Governmental Body: Van Meter Planning and Zoning Commission Meeting

Discussion and Possible Action: Van Meter Community School District - Site Plan #3

Site Plan #3 was submitted on December 11, 2024. Documents included: Application, Existing Conditions HydroCAD report, Proposed Conditions HydroCAD report, Elevations, Civil Set, Stormwater Report, and North Parking Lot Photometrics.

VAN METER, IOWA
VAN METER SCHOOL ADDITION
SITE PLAN REVIEW

SHEET NAME:
EXTERIOR ELEVATIONS

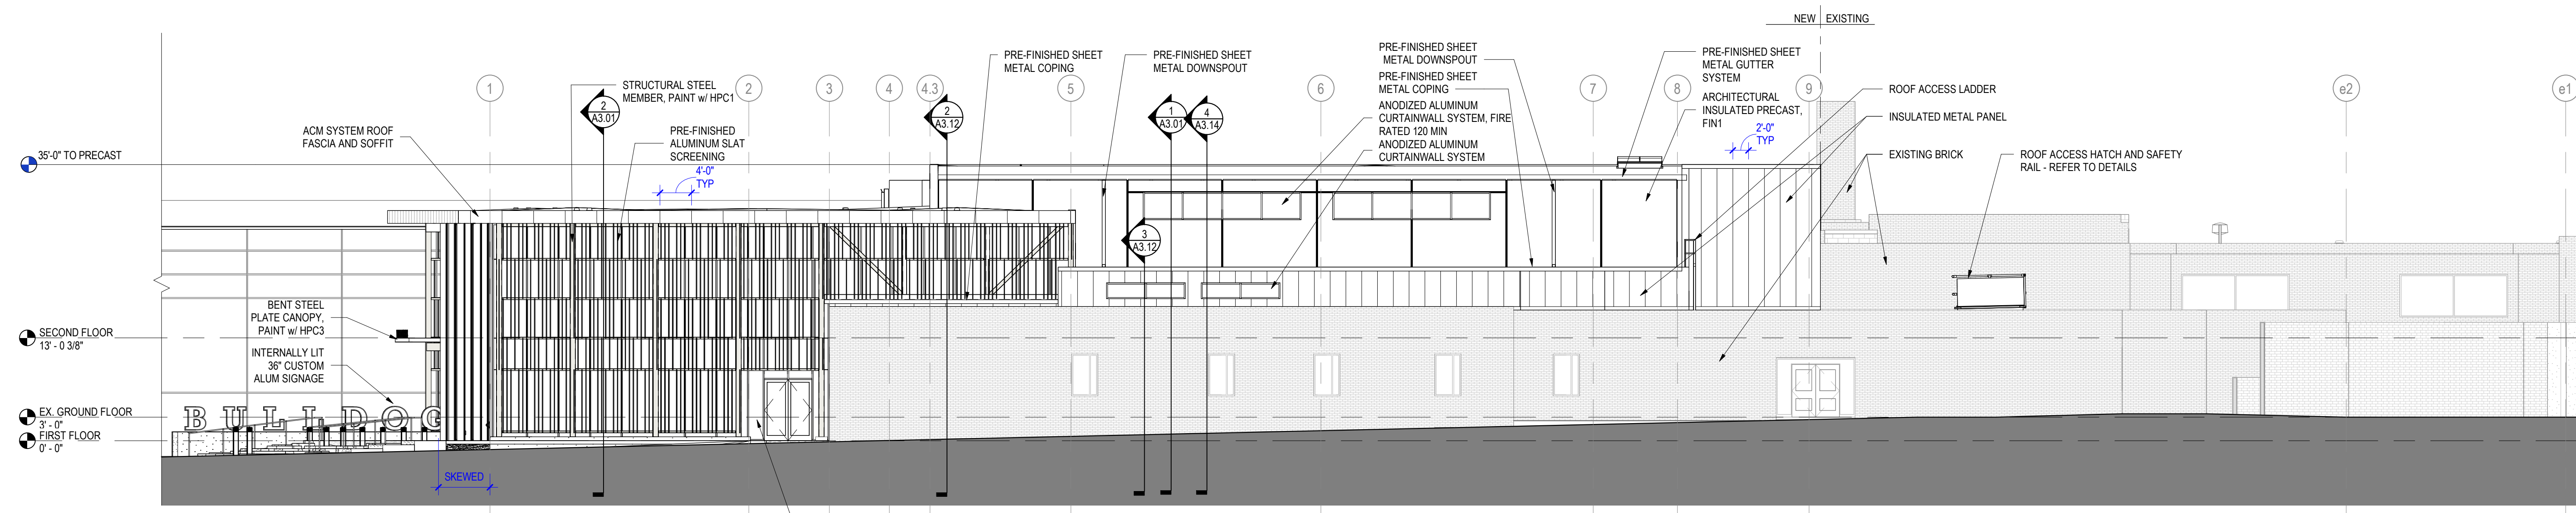
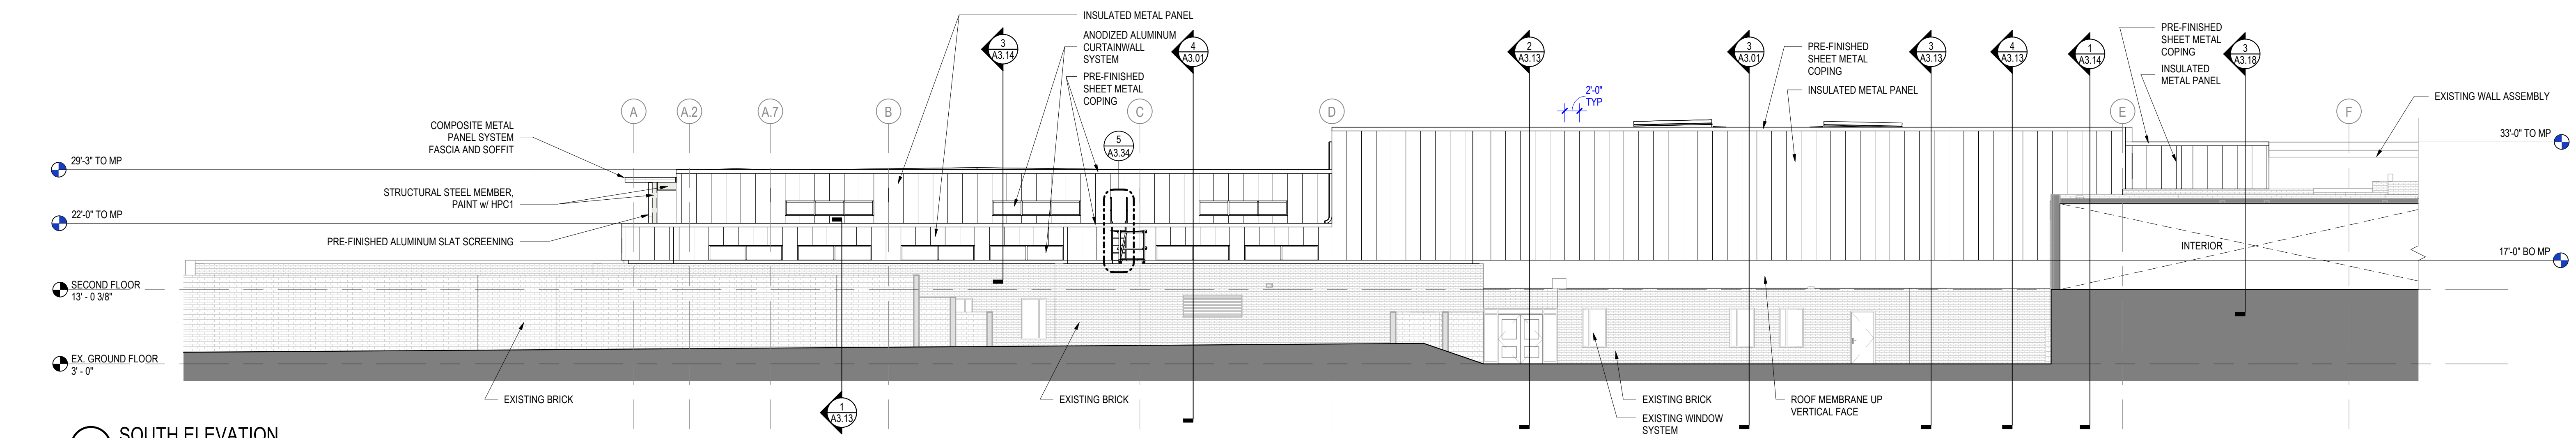
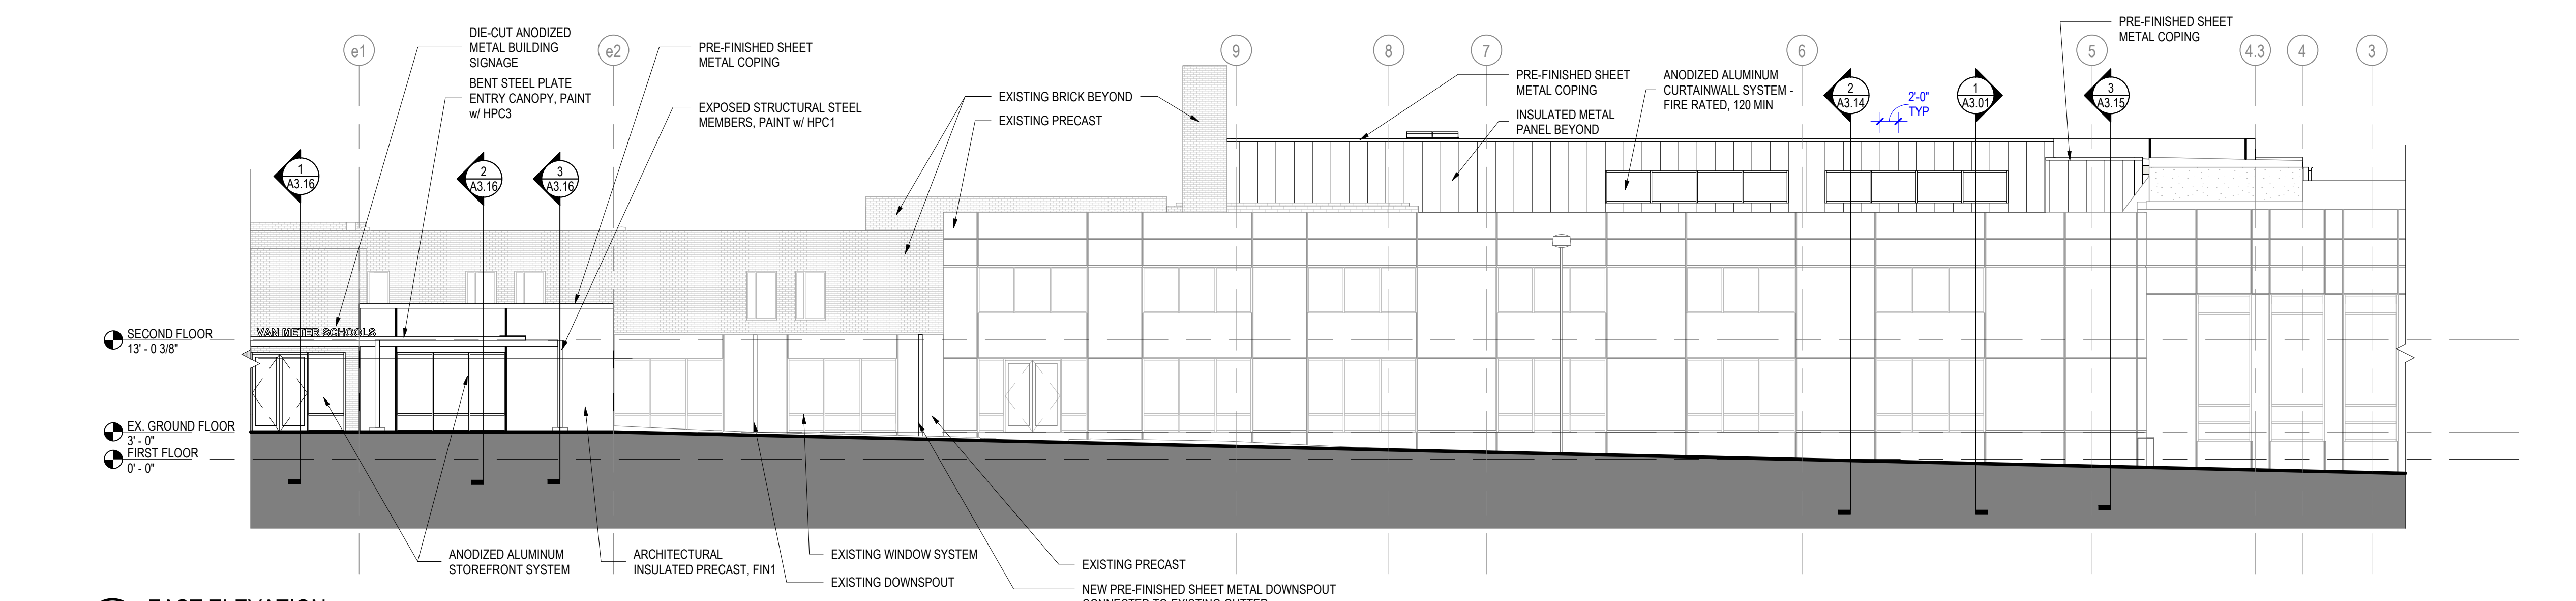
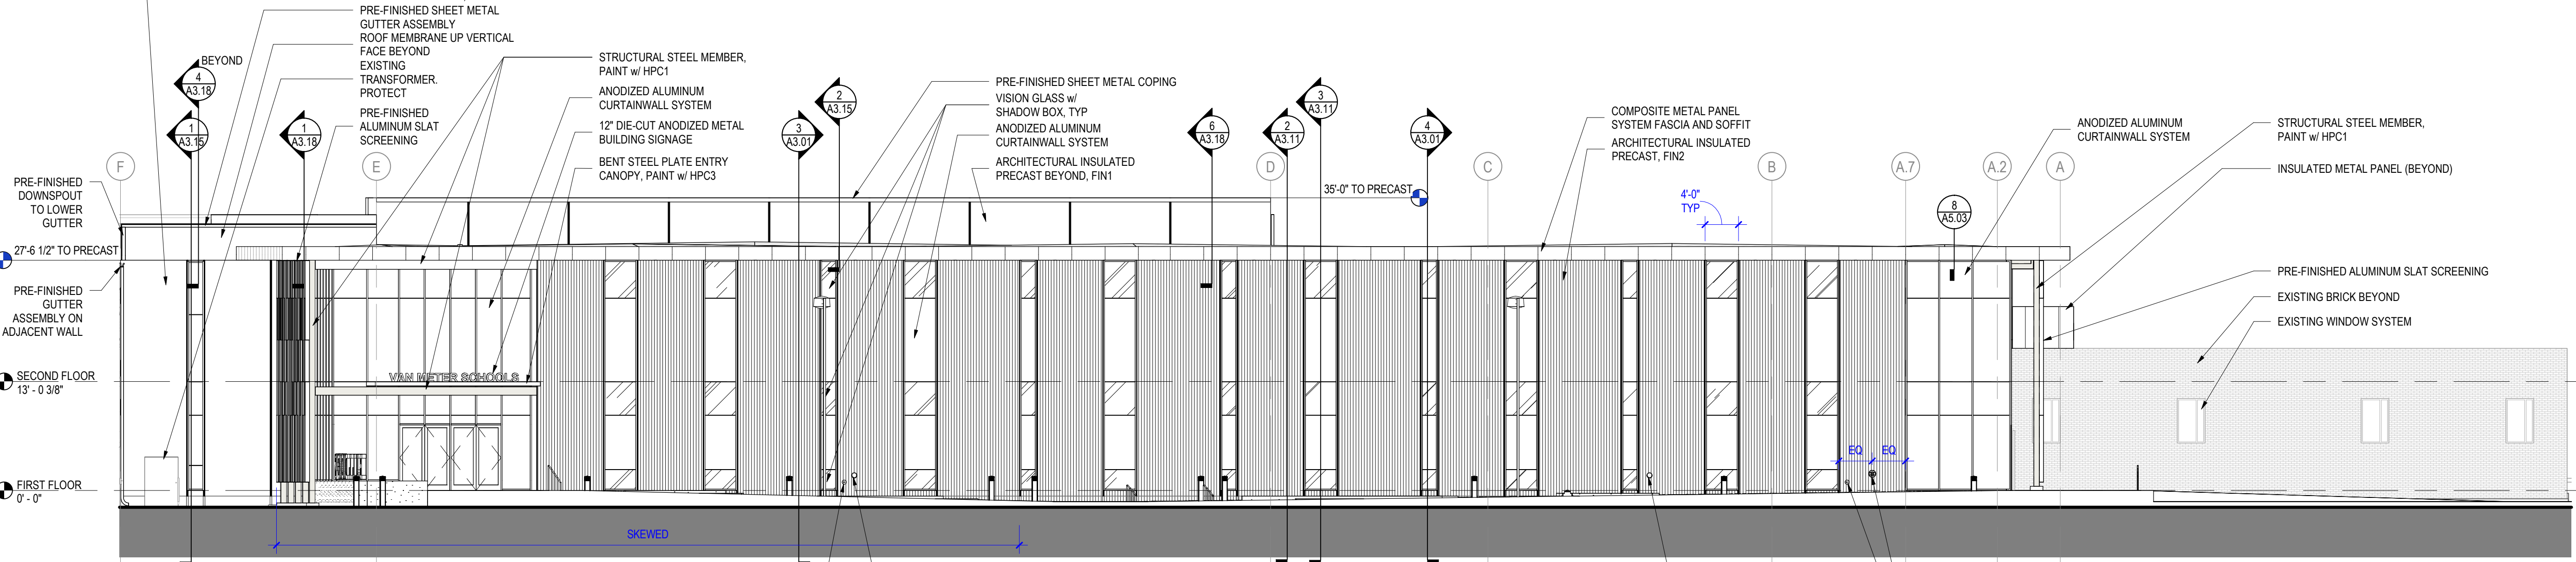
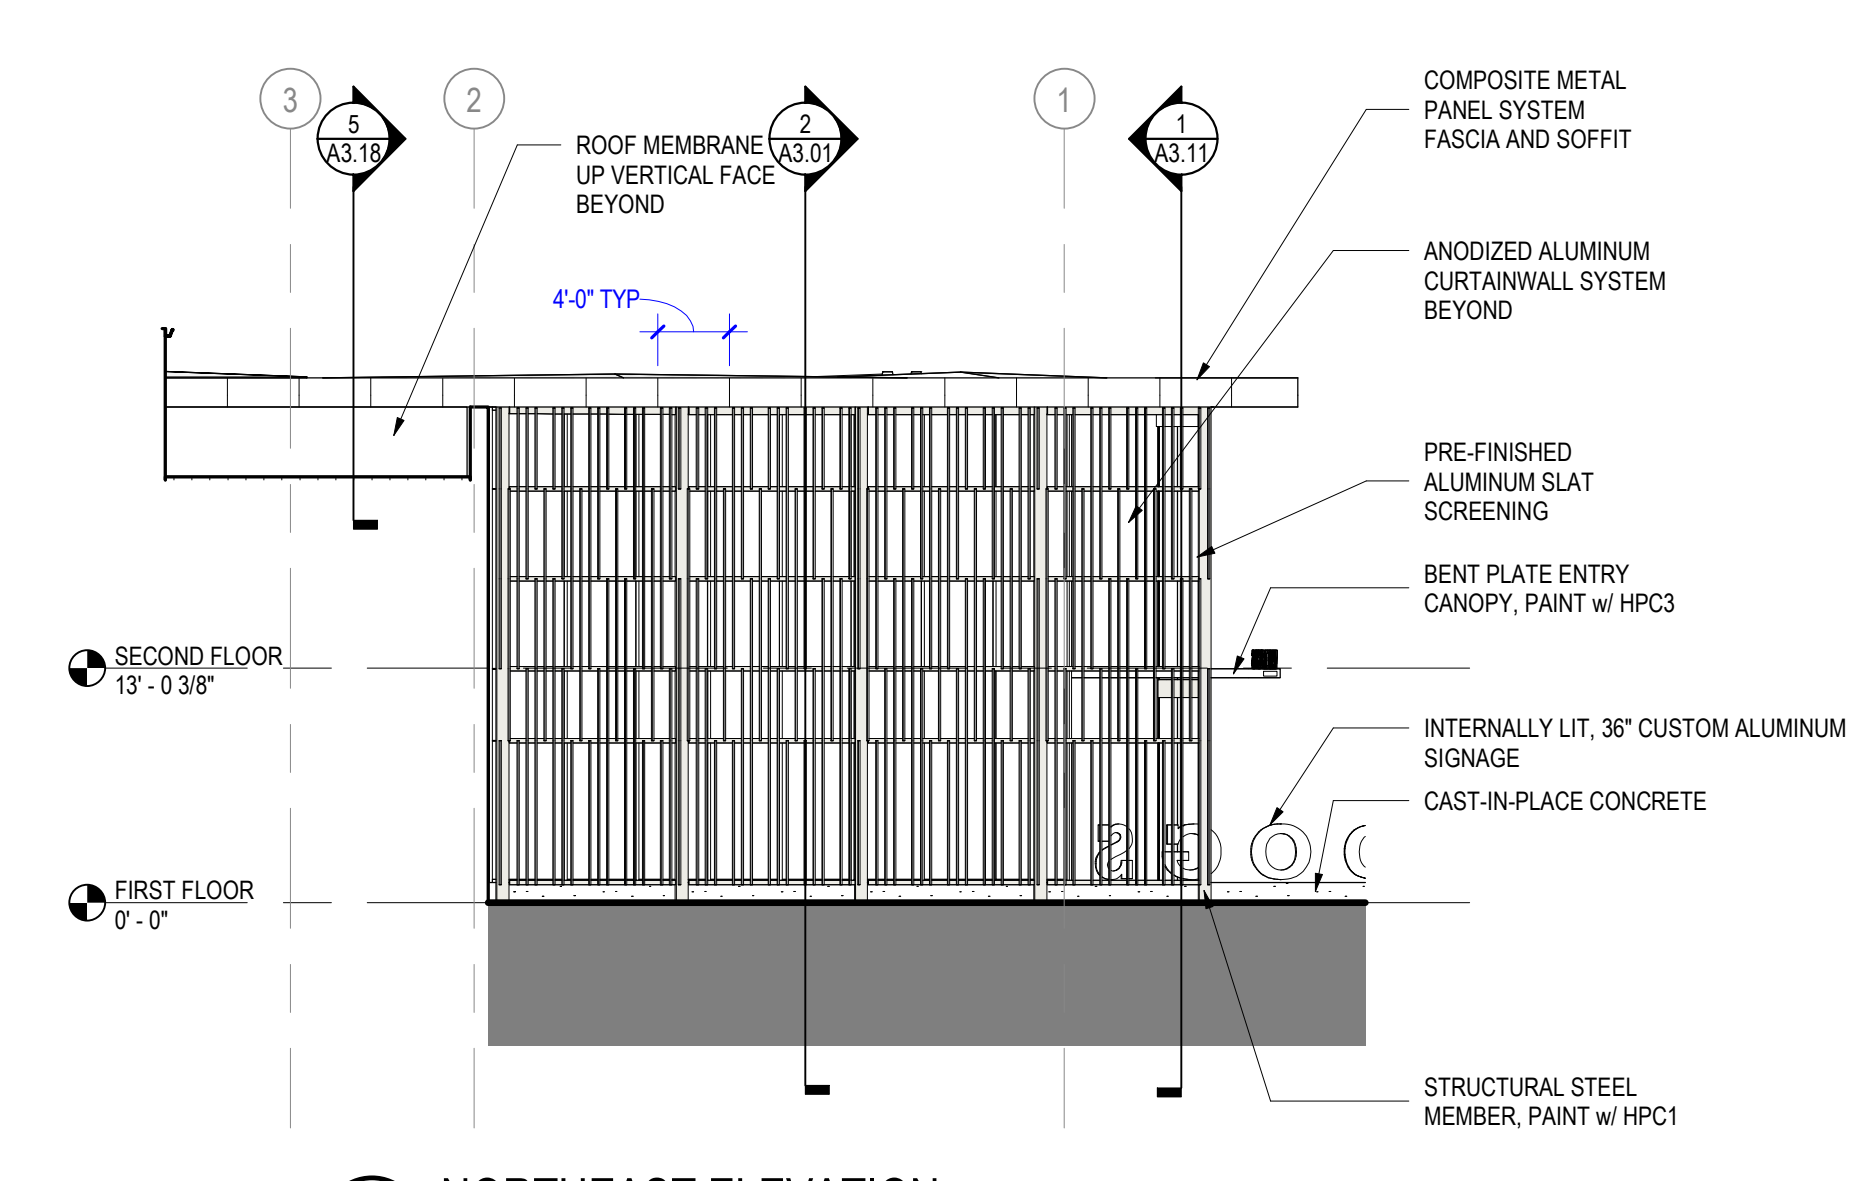
6. The proposed use of exterior materials, for the buildings or structures should meet the intent of Chapter 171 of the City Code. The drawing elevations of the new school addition have been provided with the application. It is suggested that rendered color drawings of the elevations be provided that clearly show the additions and the existing school. Also elevations of the concession, restroom and weight room buildings should be provided for review by City.

- Overall site plan of the property indicating the new improvement compared to existing site. The site plan can include existing public utilities and easements as well as existing City owned property.
- Elevations with colors to ensure the new and existing are what the City is expecting the building to appear.
- Light Fixture type for light pole for City's review. Gage just provided the attached cut sheet. This would be acceptable to V&K but wanted to confirm the profile is acceptable to City.
- Overall drainage plan of the property showing how each subarea drains to offsite areas.
